### CONDITIONAL USE AND SITE PLAN AND DESIGN REVIEW STAFF REPORT AND RECOMMENDED CONDITIONS OF APPROVAL

**FILE NO.:** CU 15-01: Conditional Use  
SP 15-10: Site Plan and Design Review

**REQUEST:** Site Plan and Design Review and Conditional Use application for an expansion of the PGE Abernethy Substation on Main Street between 17<sup>th</sup> and 18<sup>th</sup> Streets.

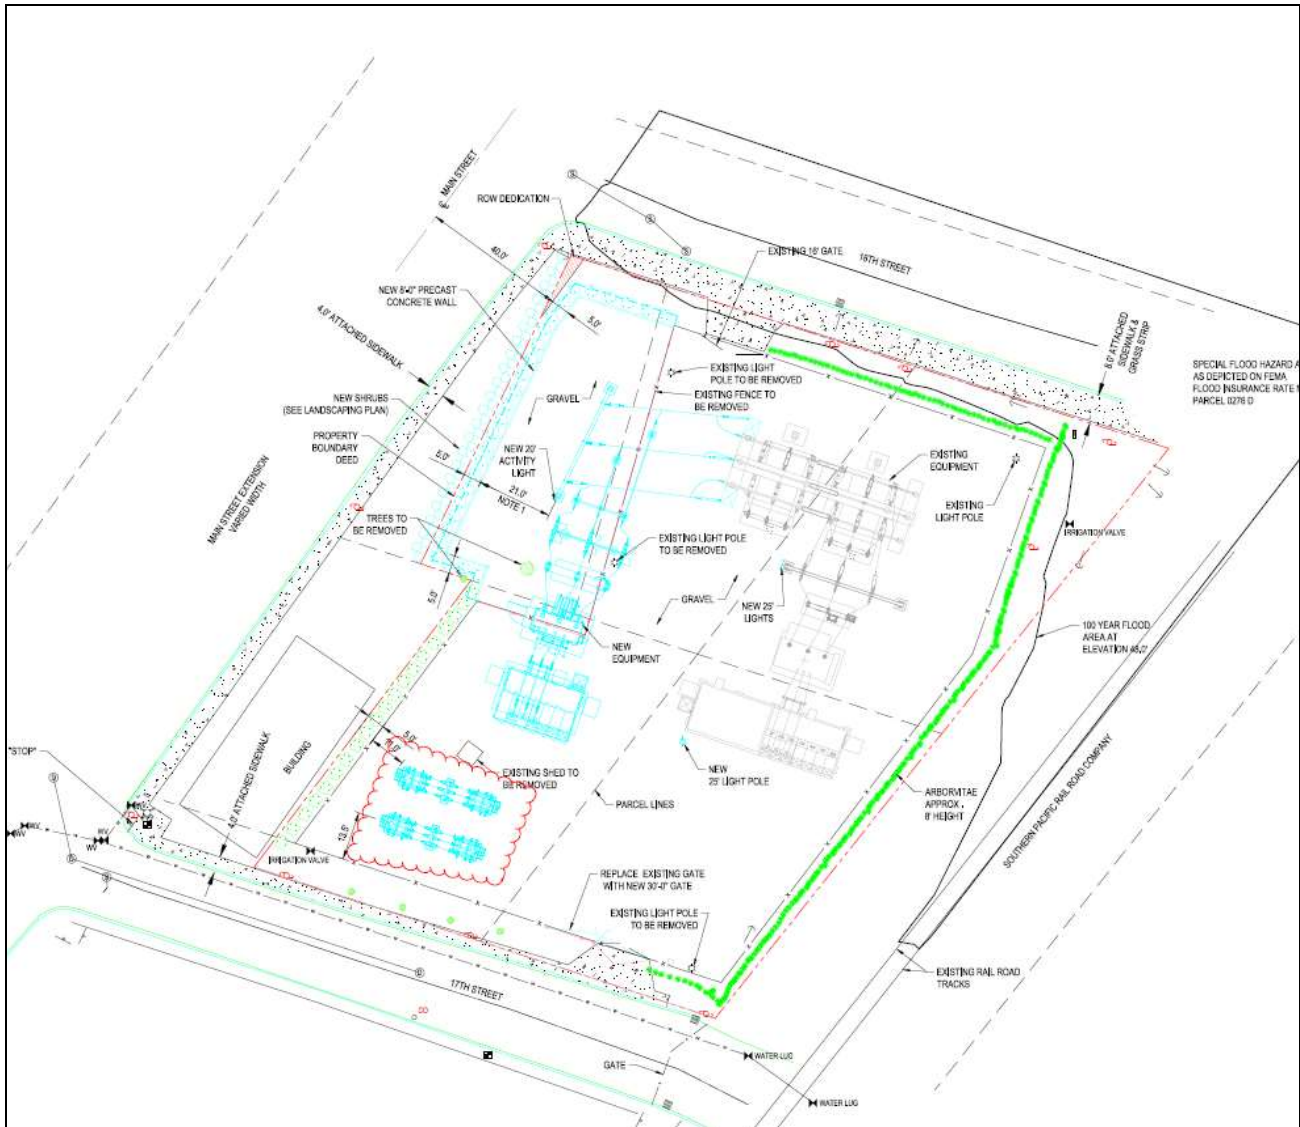
The expansion includes an 8-foot wall (brick look) along the Main and 18<sup>th</sup> Street frontages of the proposed expansion. PGE has installed a similar type of wall (although taller at 12 feet) around the Stephenson Substation across from OMSI in Southeast Portland. The same type of wall (also at 12 feet) will be installed along the primary street elevation of the new Marquam Substation south of downtown Portland.

For safety and security reasons, PGE proposes to install 3 strands of barbed wire along the inside of the wall, angled internal to the substation. However, the barbed wire will not be visible to the public along the street frontages and it is intended to provide barriers to climbing or other unauthorized entry.
